Our Case Number: ABP-317742-23

Re: BusConnects Bray to City Centre Core Bus Corridor Scheme
Bray to Dublin City Centre.

**Written Submission from Dublin City
Council Chief Executive
to An Bord Pleanála
in relation to
the National Transport Authority's
BusConnects Dublin – Bray to City Centre Core Bus Corridor Scheme
An Bord Pleanála Ref. HA27.317742**

Hatch Street Lower: The drawings inaccurately omit existing trees. No tree removals are permitted at this location.

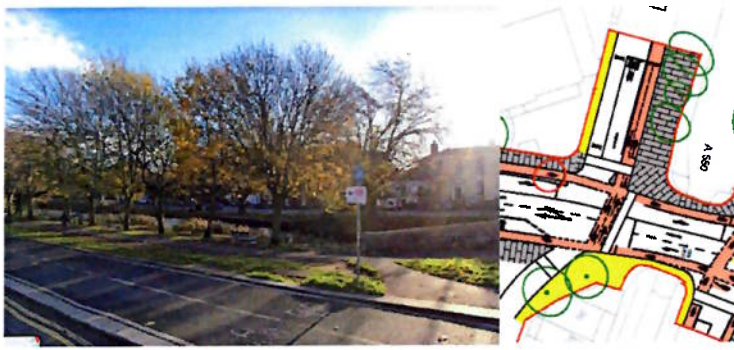
Sheet 1: All paving works should use granite surfaces and kerbing to DCC standards to reflect the quality of the St Stephens Green and Leeson Street environment.
